FLYING HORSE NORTH FILING NO. 4

PUD PRELIMINARY PLAN

A MINOR AMENDMENT TO THE 2016 FHN PUD

PUD PRELIMINARY PLAN MINOR AMENDMENT
COVER
SHEET C 1

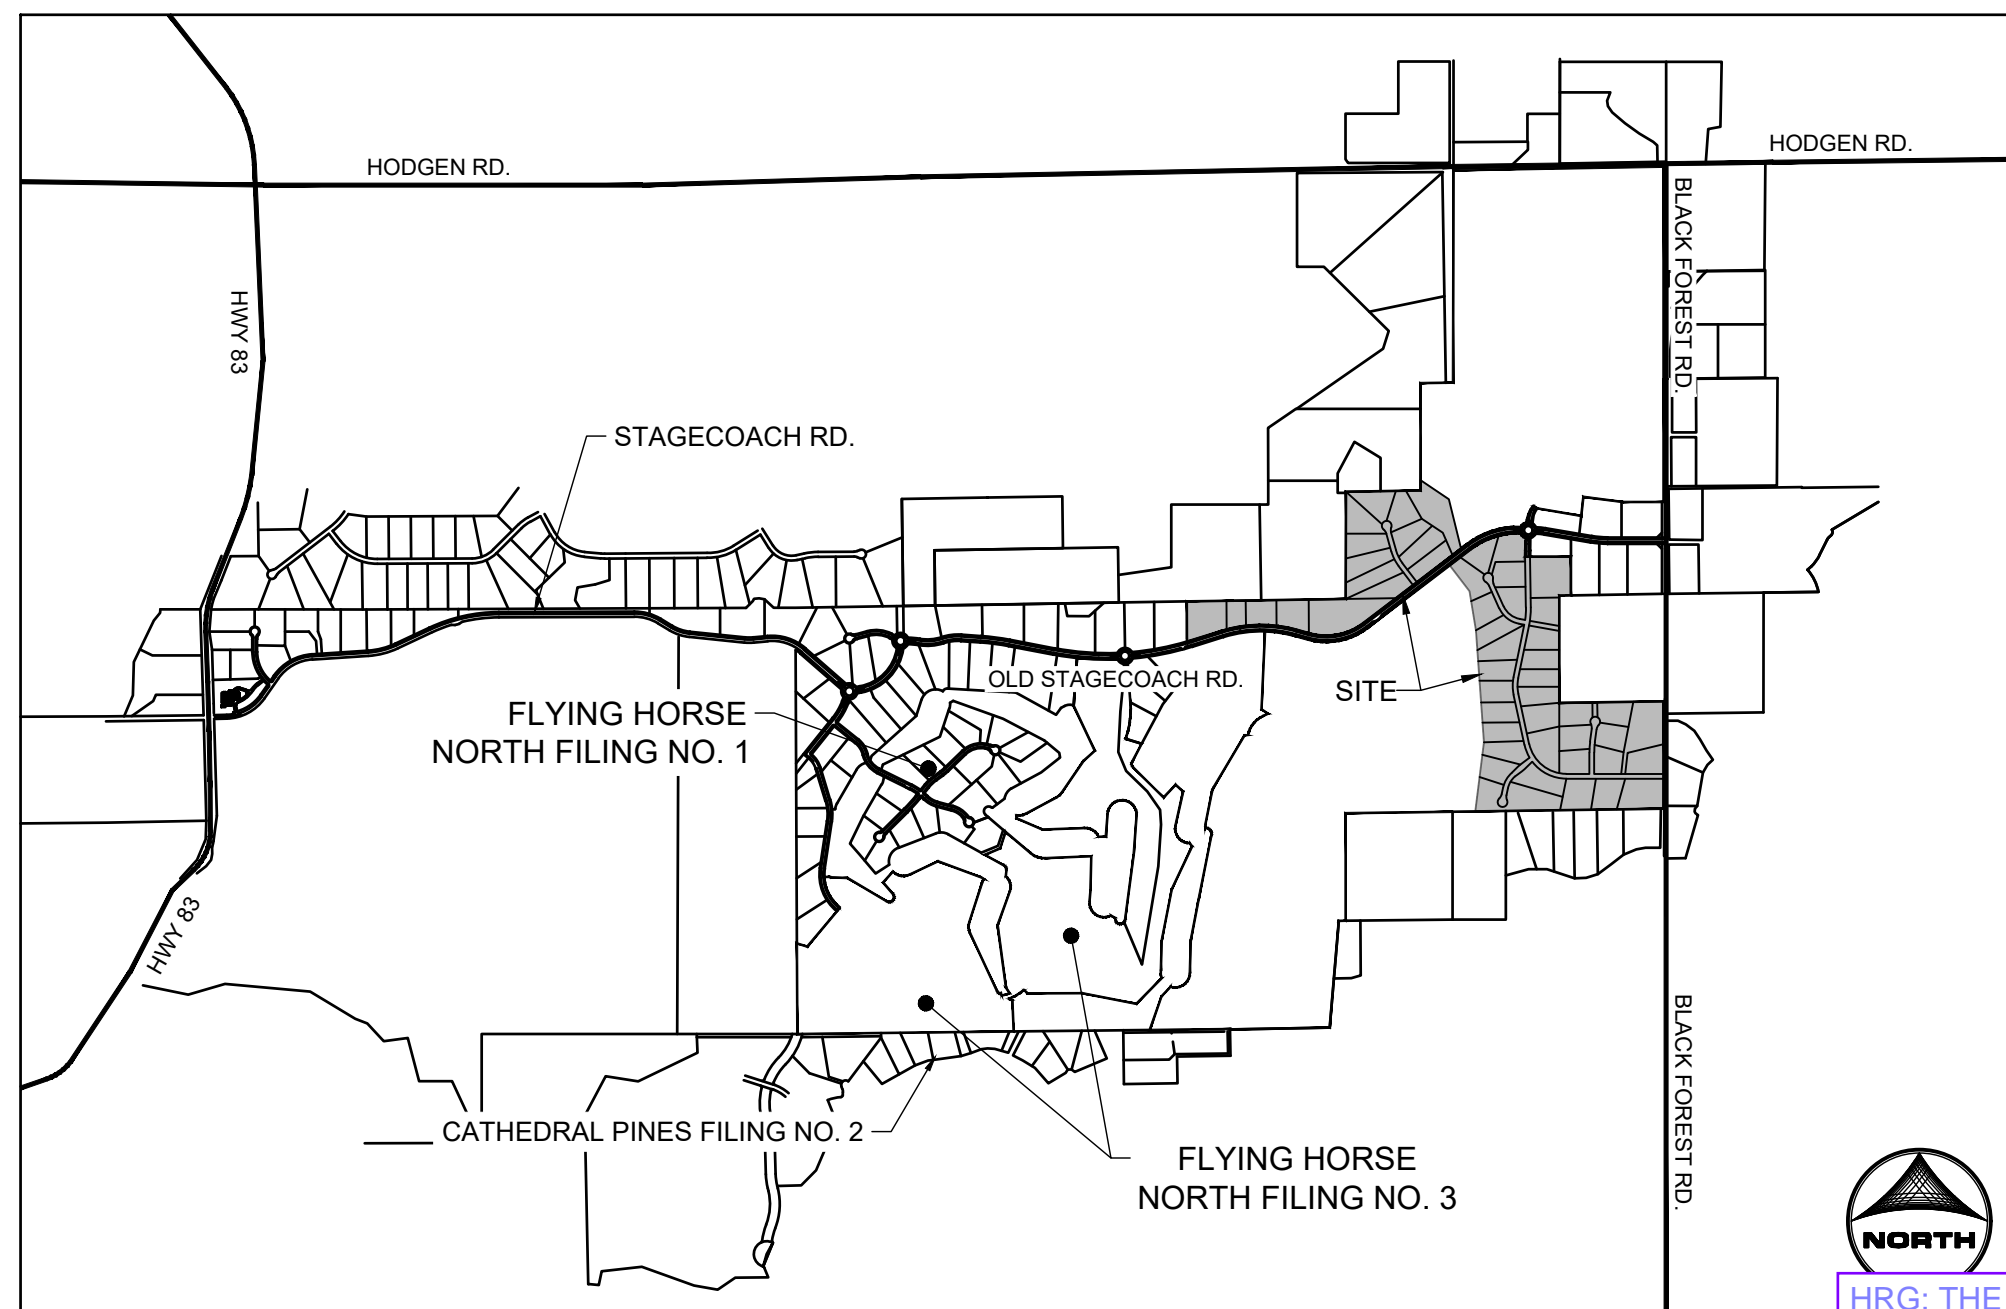
Title block needs to be reworked as follows:

FLYING HORSE NORTH FILING NO. 4 Amendment to FLYING HORSE NORTH PUD Development Plan / Preliminary Plan

All of the notes from the original PUD / Preliminary Plan need to be carried over to this plan.

Include the original preliminary plan

Is the sketch plan still relevant?

Include both the original PUD and preliminary plan file numbers and the new file number.

HRG: REVISED.

HRG: THE ONE GENERAL NOTE FROM THE ORIGINAL PLAN HAS BEEN ADDED TO THE GENERAL NOTE SECTION ON THIS COVER PAGE.

HRG: THE ORIGINAL IS ALREADY LISTED THE RECORDING DATE WAS WRONG. THAT HAS BEEN UPDATED.

HRG: REMOVED.

HRG: UPDATED.

HRG: PAST PUD/PRELIM FIL NUMBERS ARE INCLUDED IN THE PROJECT HISTORY TRACKER ABOVE. NEW FILE NUMBER HAS BEEN ADDED HERE.
